REMARKS

Atty-Docket No. M-15241 US
Application No. 10/632,186
Reply to Office Action of July 12, 2004
Annotated Sheet Showing Changes

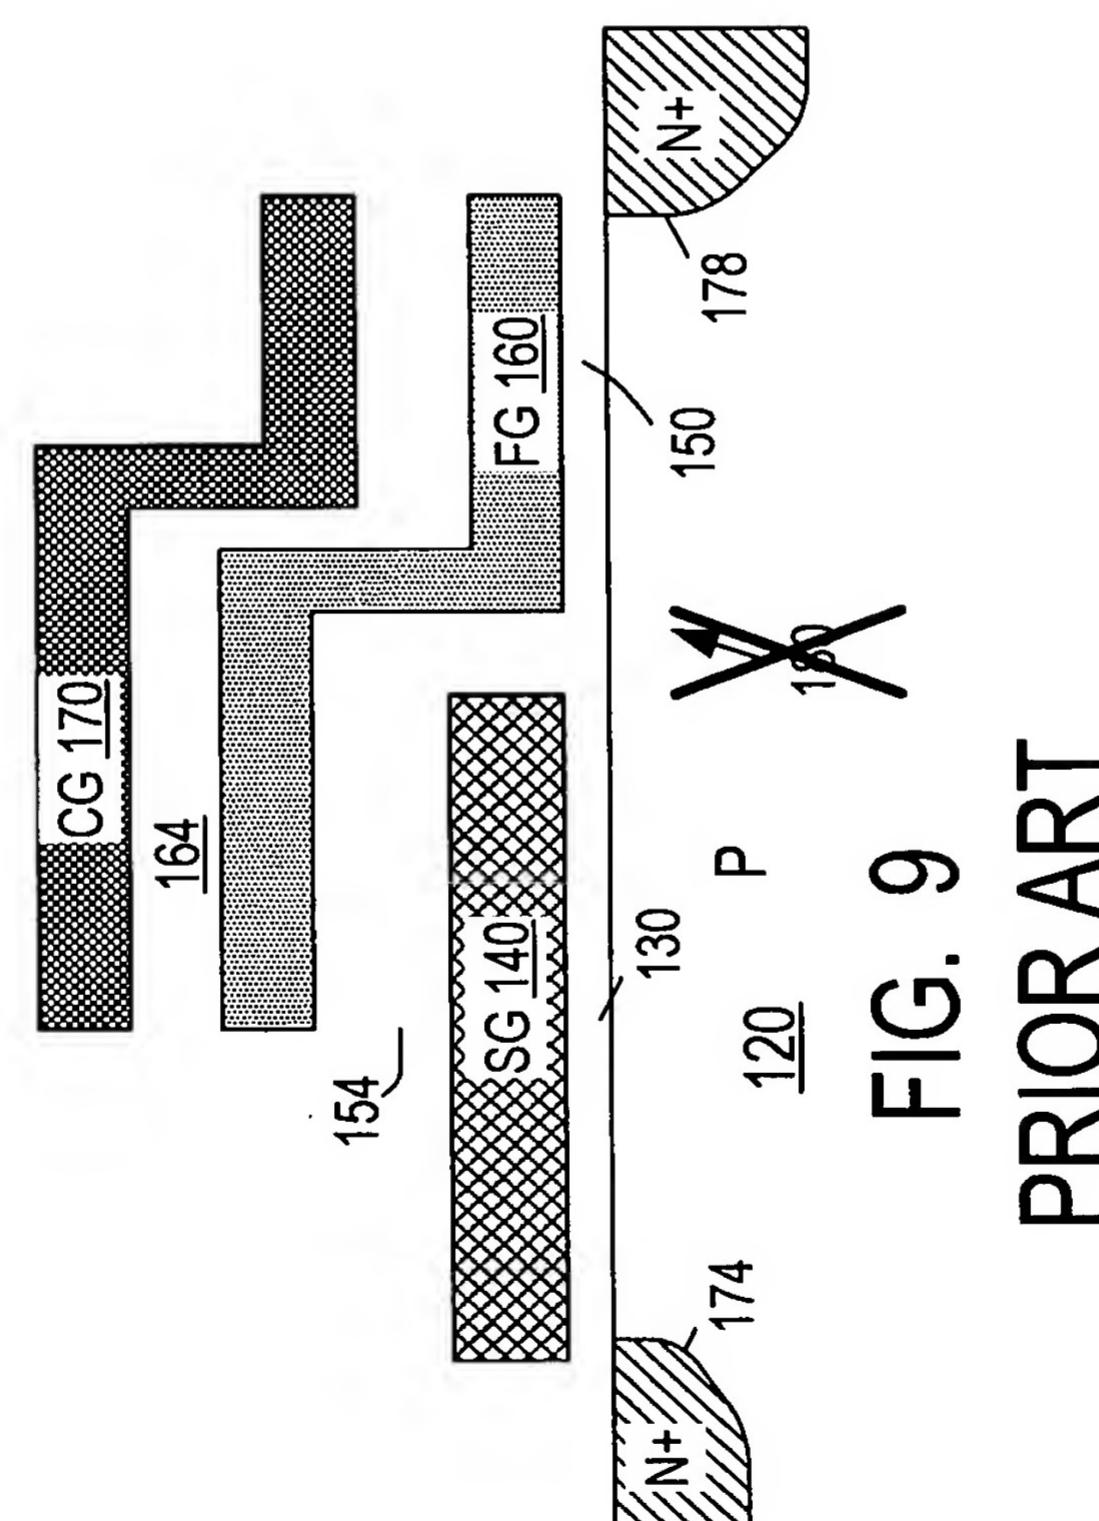
The attached drawing sheet no. 3 includes an amended Fig. 9 with a reference numeral 180 deleted.

FIG. 10A

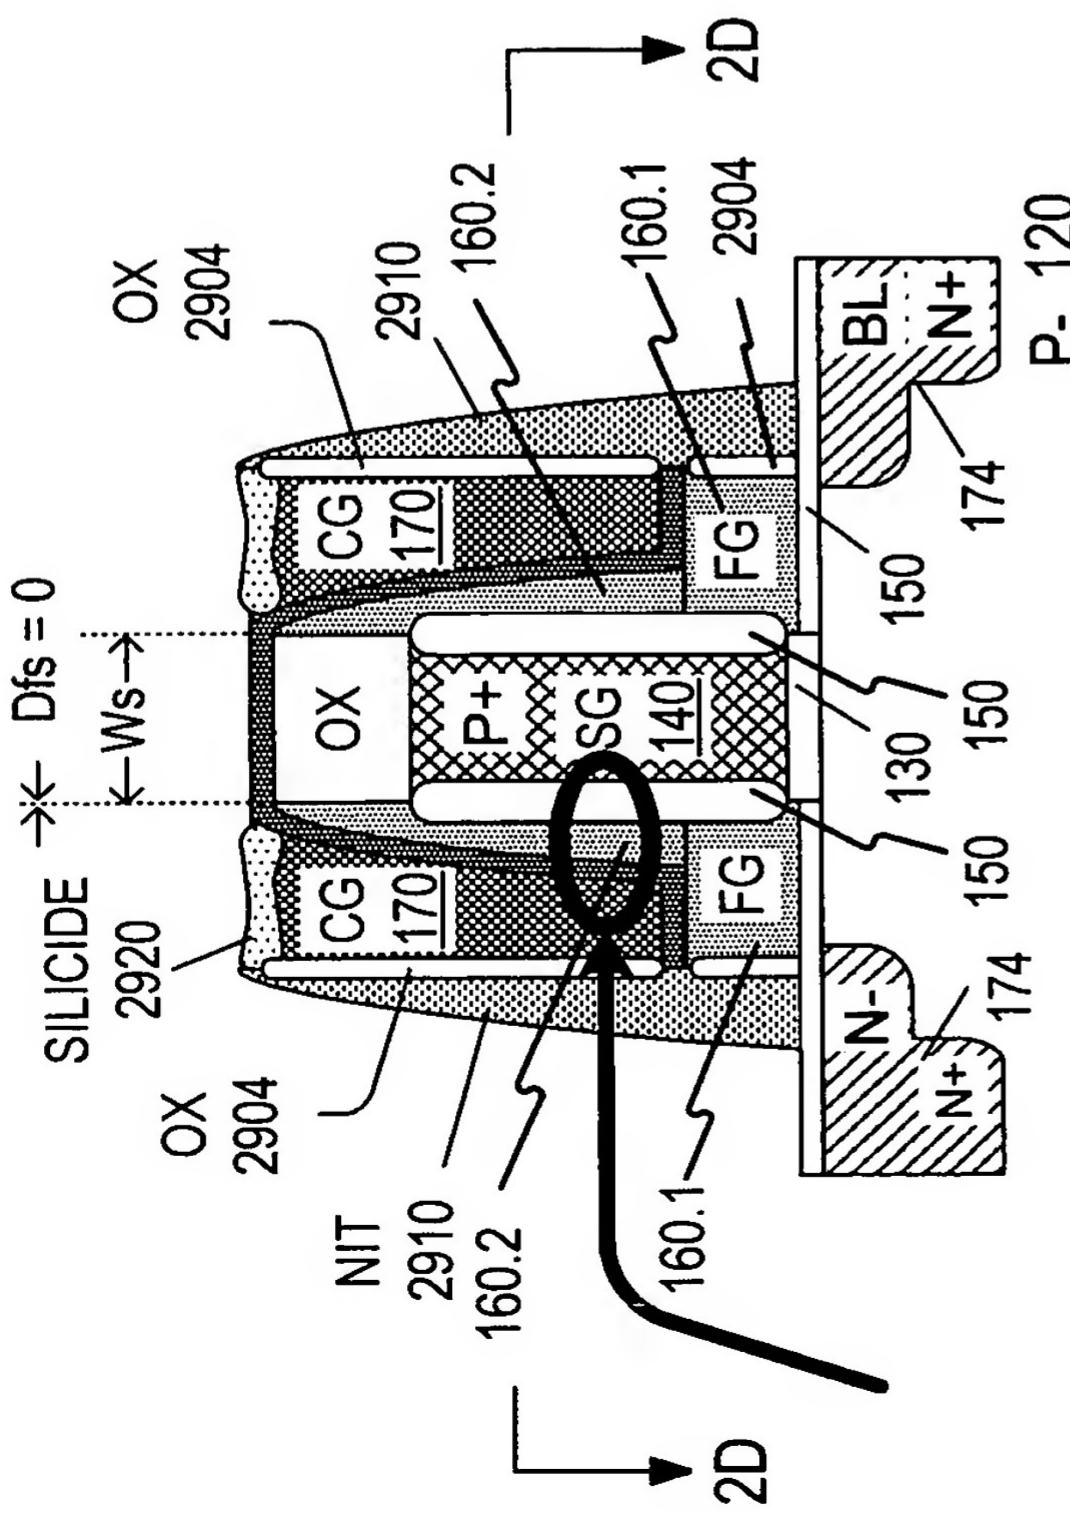
The attached drawing sheet no. 4 includes an amended Fig. 10A. Fig. 10A includes two reference numerals 160.2, one on the left and one on the right. The lead line from the numeral 160.2 on the left is extended to point to a floating gate portion symmetrically with the lead line from the numeral 160.2 on the right.
